# CONSTANTINI-SANDIFER (MINOR PLAT)

<p><b>Applicant</b> Victor Farina, President Farina and Sons Inc.</p> <p><b>Owner</b> Anthony Costantini Shari Sandifer</p> <p><b>Project Planner</b> Jacques Coulon</p>	<p><b>Property Location:</b> 3215 Middlesex Rd. ((south side of Middlesex Rd., west of Nottingham St., northeast of Dorchester St.) (Parcel #12-22-29-6444-39-140; 0.39 acres, District 3).</p> <p><b>Applicant's Request:</b> Minor plat request to replat the subject property to accommodate the construction of a single-family residence on a currently empty lot.</p>	<p><b>Staff Recommendation:</b> Approval of the replat, subject to conditions in this staff report.</p>
<p><i>Updated: May 27, 2016</i></p>

# 2015 SURVEY

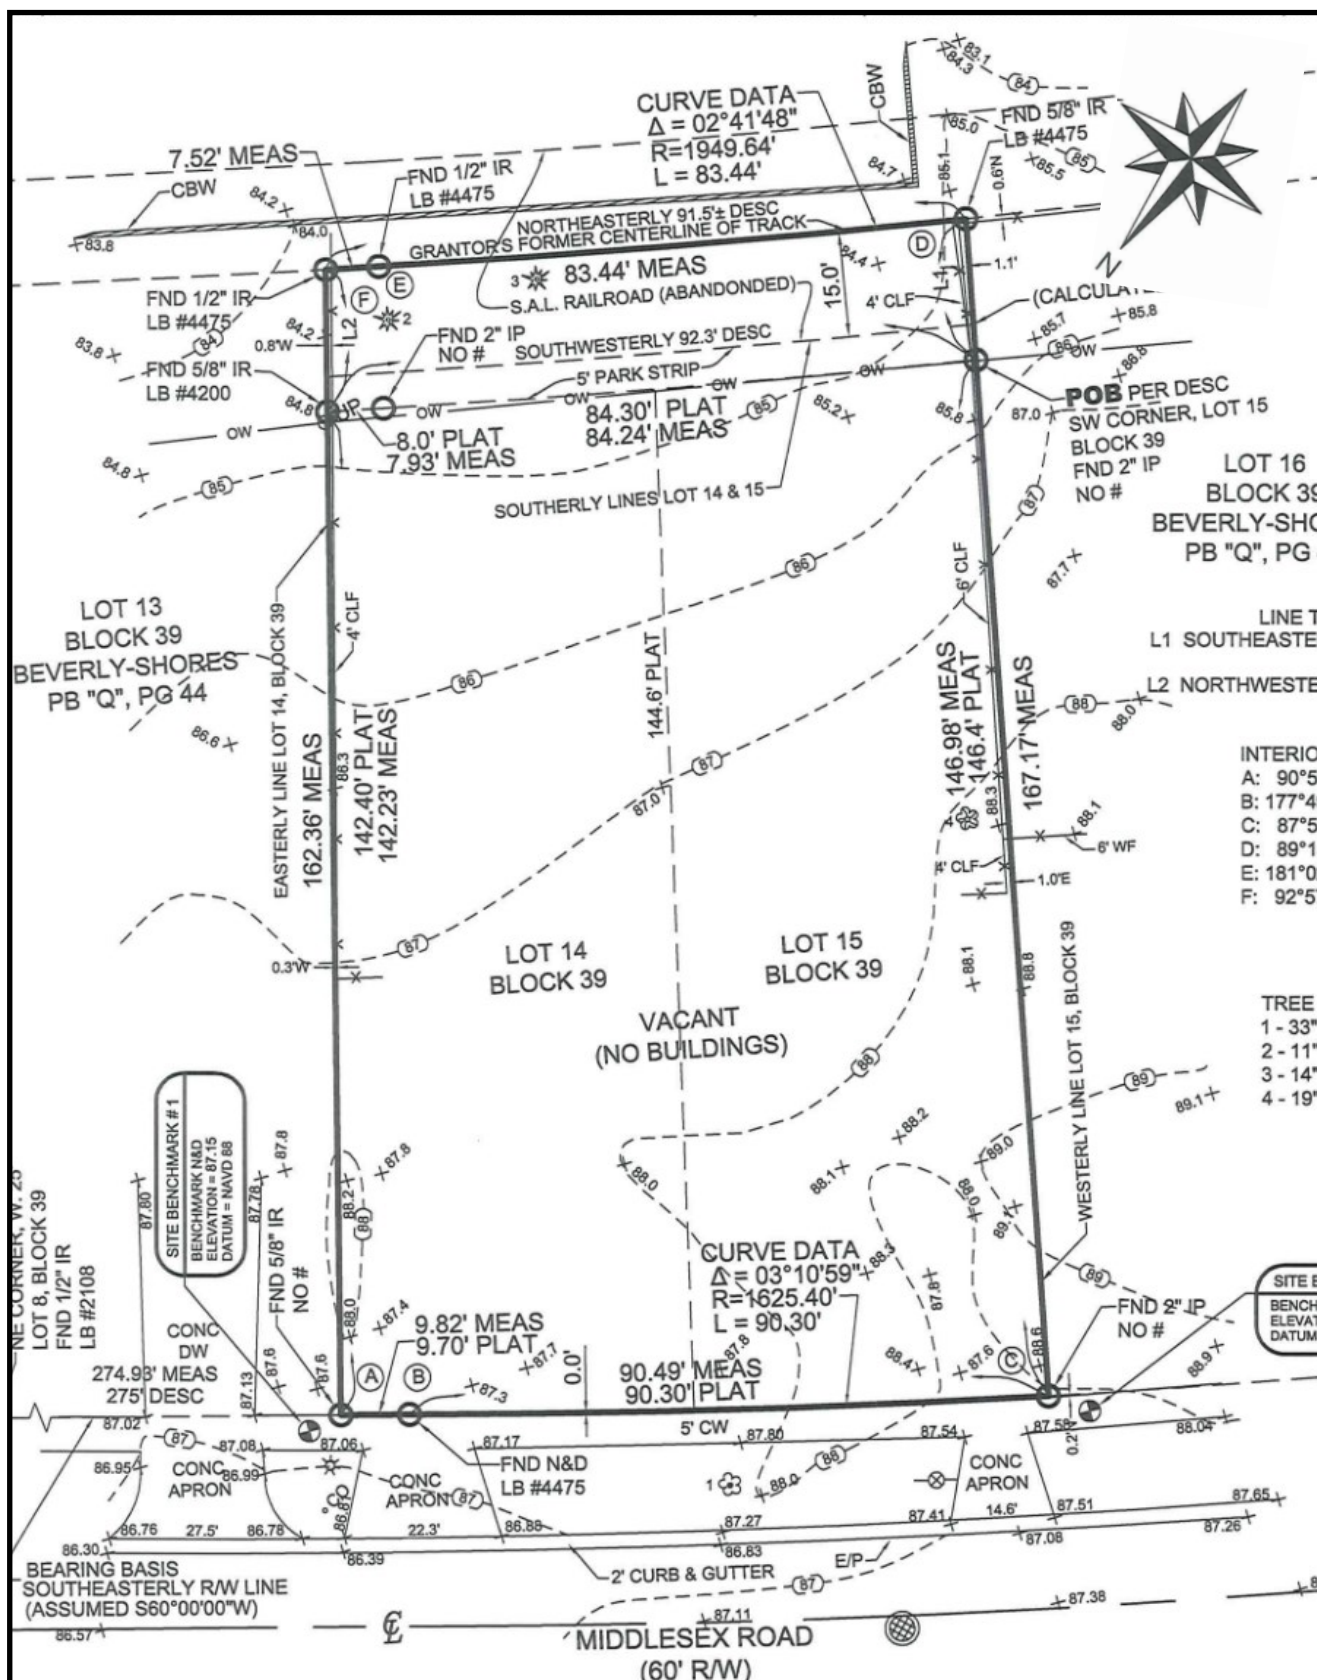
1. A title opinion or certificate pursuant to FS 177.041(2) must be submitted.

1. Sidewalk - As per Section 61.225 of the Land Development Code, a 5 foot wide concrete sidewalk is required along all dedicated rights-of-way. Any existing sidewalk damaged or broken is to be repaired.

4. Concurrency Management/Plat - The final recorded plat shall contain the following note: "Development on the property depicted on this plat is subject to the requirements of Chapter 59, the Concurrency Management Ordinance of the City of Orlando, which governs the City's ability to issue building permits on this property. Approval of this application shall not be deemed to provide any vested rights, except as to those matters depicted hereon, that are consistent with the requirements of Chapter 177, Florida Statutes, or were required by the City of Orlando as a condition of platting."

5. Storm-Water Management District - The owner/developer is required to design and construct an on-site storm water system in accordance with the Orlando Urban Storm Water Management Manual and the approved Master Drainage Plan. Approval from St. Johns River Water Management District is required. The system is to be privately owned and maintained.

3. Sewer - Verify with the Wastewater Division that a sewer lateral will be available for connection of all newly created lots.
4. OUC Water - Applicant / Developer / Customer shall contact OUC regarding requests to establish new or modify existing electric, water or convenient lighting services. Please be advised that OUC approval is subject to respective reviews and approval by OUC Water, Electric and Lighting. Please submit detailed utility construction plans to OUC's Development Services email address: DevelopmentServices@ouc.com. Additionally, please refer to the OUC Pre-Application Checklist for City of Orlando Permits.
